Access Compliance Report Public Rights-of-Way (Curb Ramps)

Intersection ID: 31937 Main Street: CRANBORNE CHASE CT **Cross Street: STOKES AV** Location: SE ADA ID: 966856470C63 Ramp Type: PerpDiag Initial Pass/Fail: Fail **Overall Compliance: No Severity Score:** 30

STOKES AV Street 1 Name Stop Condition-Street 2 Street 2 Name **CRANBORNE CHASE CT** Stop Condition-Street 1

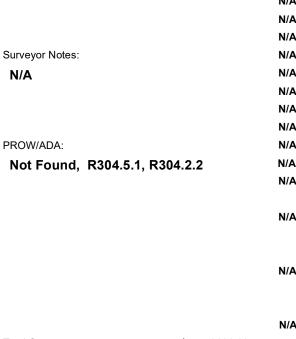
Not Found, R304.5.1, R304.2.2

Field Measurements/Component Compliance					
Compliance Description		Data	Comp	liance Description	Data
N/A	Ramp Length (in)	49.0	No	Ramp Slope (%)	9.0
No	Ramp Width (in)	32.0	Yes	Ramp XSlope (%)	0.7
N/A	Flare Type LT	N/A	N/A	Flare Type RT	N/A
N/A	Flare Slope LT (%)	N/A	N/A	Flare Slope RT (%)	N/A
N/A	Flare Traversable LT?	N/A	N/A	Flare Traversable RT?	N/A
N/A	Landing Length (in)	N/A	N/A	DWS Provided?	N/A
N/A	Landing Width (in)	N/A	N/A	DWS Contrast?	N/A
N/A	Landing Slope (%)	N/A	N/A	DWS Length (in)	N/A
N/A	Landing X Slope (%)	N/A	N/A	DWS Full Width?	N/A
N/A	Landing Curb? (Y/N)	N/A	N/A	DWS Offset (in)	N/A
N/A	Shared Landing?	N/A			
N/A	Gutter Ponding?	N/A	N/A	Gutter Slope (%)	N/A
N/A	Gutter Lip Ht (in)	N/A	N/A	Gutter X Slope (%)	N/A
N/A	Painted X Walk1?	No	N/A	Painted X Walk2?	No
	X Walk 1 Direction	To NE		X Walk 2 Direction	To NW
N/A	X Walk 1 Width (in)	N/A	N/A	X Walk 2 Width (in)	N/A
	X Walk 1 Slope (%)	2.4		X Walk 2 Slope (%)	1.5

Possible Solutions: Remove & Replace Curb Ramp With Two New Directional Ramps or Equivalent.
